STAFF REPORT
COMMUNITY DEVELOPMENT DEPARTMENT

HEARING DATE: 6/7/2022
 TO: Mayor & City Council
 FROM: Joe Dodson, Associate Planner
 208-884-5533
 SUBJECT: H-2021-0070
 Burnside (Jackson) Ridge Estates
 Subdivision

Request for Annexation & Zoning of 121.29 acres of land from RUT in Ada County to the R-2 (11.76 acres) and R-4 (109.53) zoning districts and a preliminary plat consisting of 299 total lots (275 single-family residential lots and 24 common lots) on 119.31 acres of land, by Kimley-Horn and Associates, Inc.

D. Landscape Plans (dated: 1/31/2022) (NOT APPROVED)

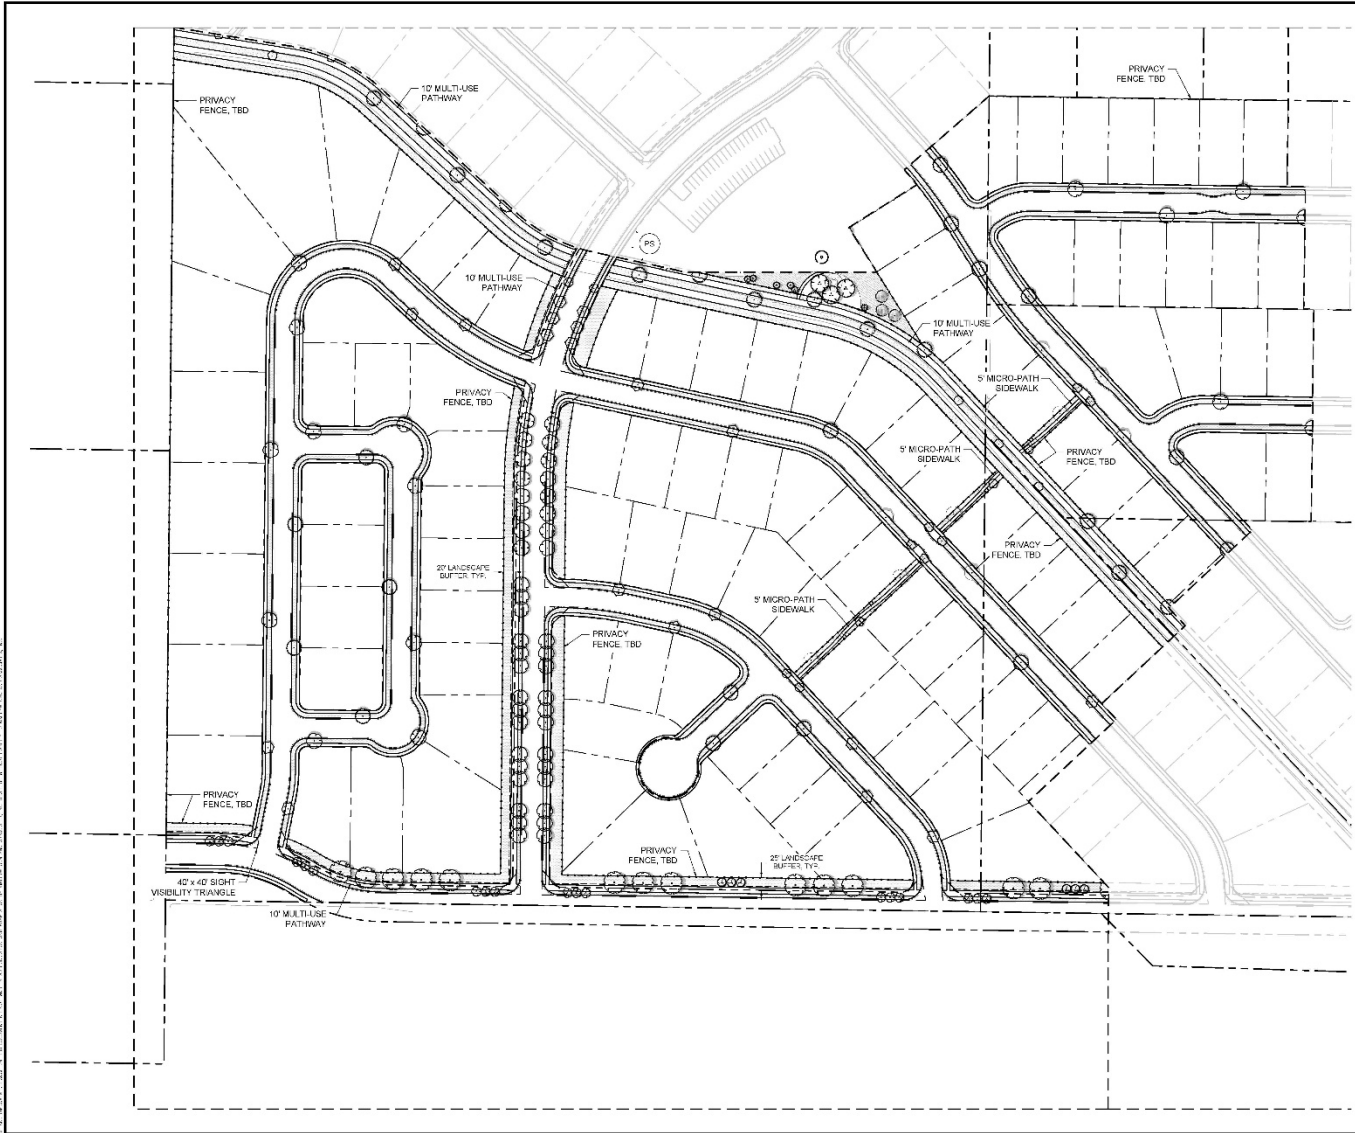
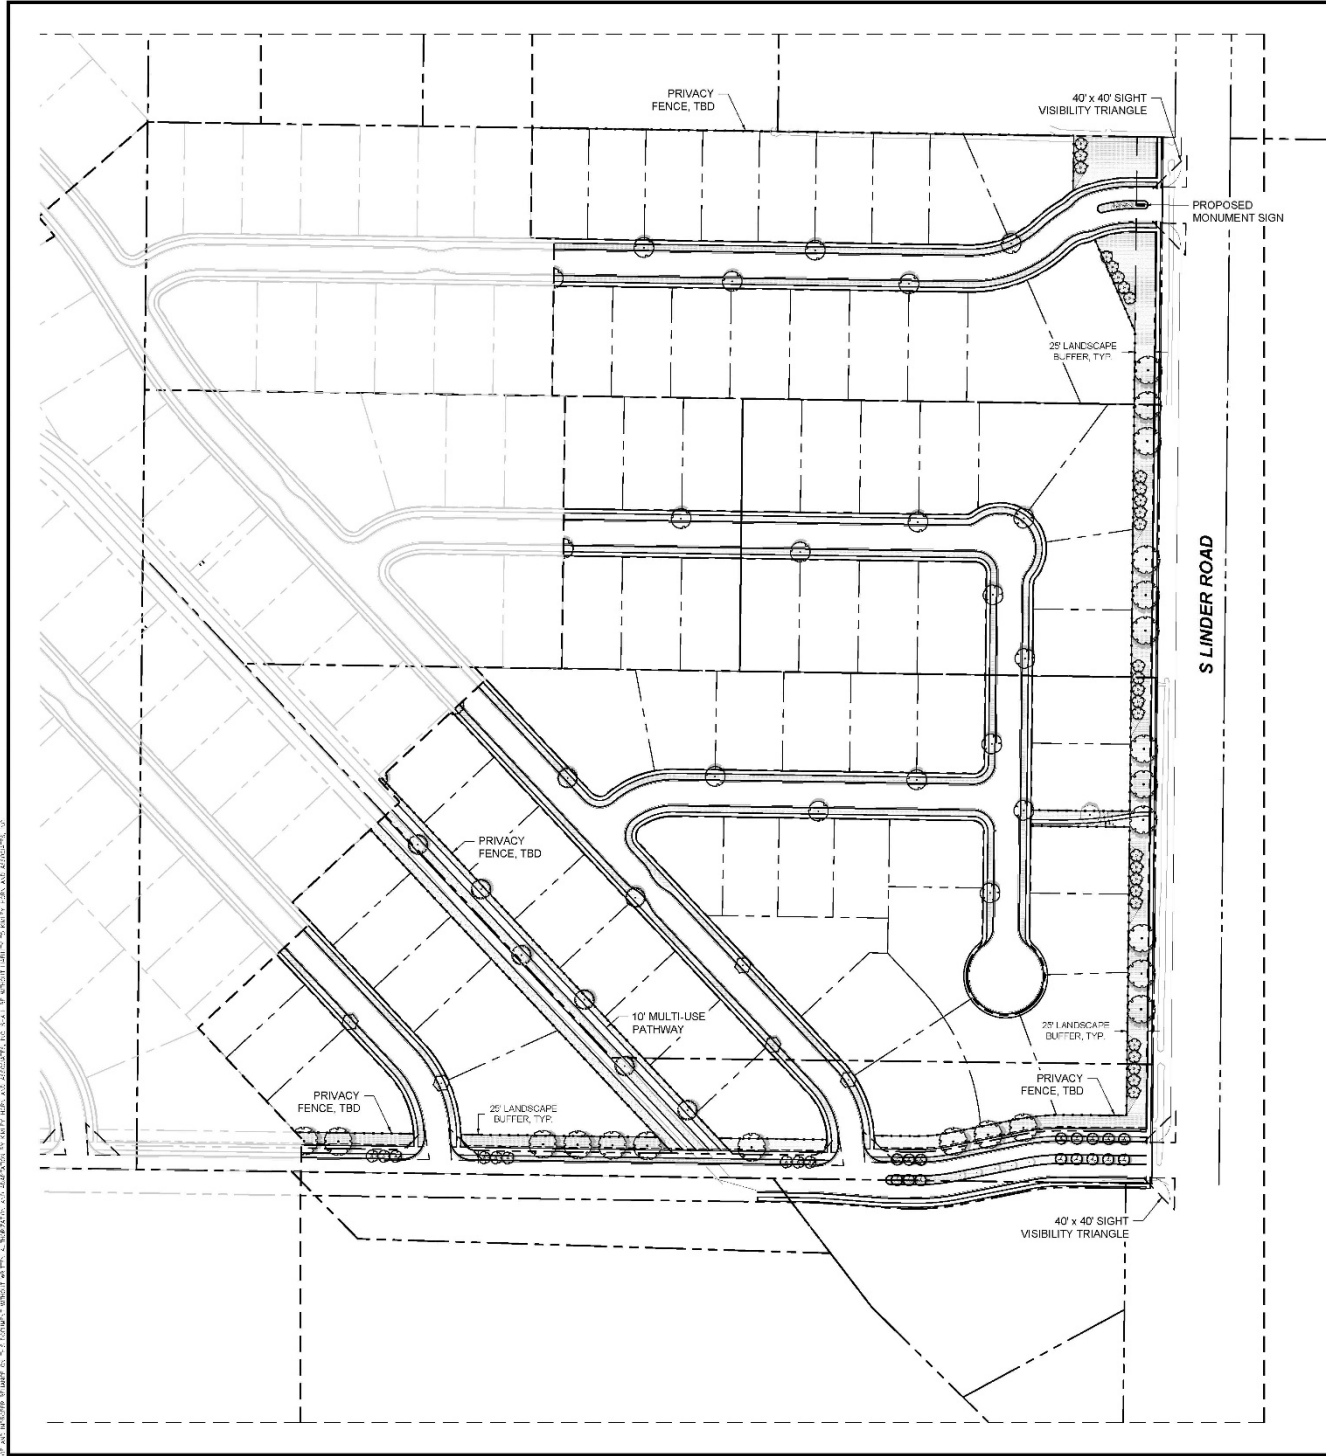
8-foot wide parkways with street trees are shown along all local streets within the development and are required to be landscaped per the standards listed in UDC 11-3B-7C. According to the submitted landscape plan, the correct number of trees ***are not*** shown and the table does not list the parkways at all. *Prior to City Council, the Applicant should correct this by adding the correct number of trees (1 per 35 linear feet) and list the linear feet of parkway within the landscape table and show the correct number trees per the provisions outlined in UDC 11-3B-7C.*

Common open space is required to be landscaped in accord with the old standards listed in UDC 11-3G-3E. The total square footage of common open space and the required number of trees to demonstrate compliance with UDC standards is not included in the Landscape Calculations table but the submitted plans appear to show UDC compliance. *Prior to City Council, the Landscape Calculations table should be corrected to include this requirement and reference the requirement of 1 tree/8,000 square feet of common open space.*

- a. Revise the landscape plans to match the revised preliminary plat as detailed above;
 - b. Per UDC 11-3B-7C, depict the correct number of trees (1 per 35 linear feet) within the proposed parkways and list the linear feet of parkway within the landscape calculations table.
